Submission: **SR33-07**

**Offshore Special Regulations – 3.14**

Interpretation - Lifelines, Pulpits and Stanchions

A submission from the Chairman of Offshore Committee  
(on behalf of the working party)

Picture 3 – Custom Boats

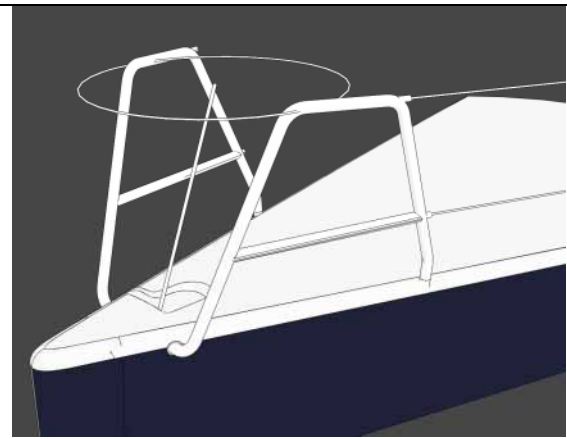
- 1) after the correspondence with the Secretariat involving proposed pulpit designs within the TP52 class. Were the pulpit bases came out of the side of the hulls it was felt advantageous to include within 3.14.3(h) the pulpit and pushpit.

Here are some photos of the issues courtesy of Mike Urwin & Andrew Williams

- h) Stanchion or pulpit or pushpit bases shall not be situated outboard of a working deck. For the purpose of this rule a ~~stanchion or pulpit~~ the base shall be taken to include a sleeve or socket into which a ~~stanchion or pulpit~~ the tube is fitted but shall exclude a baseplate which carries fixings into the deck or hull. \*\*
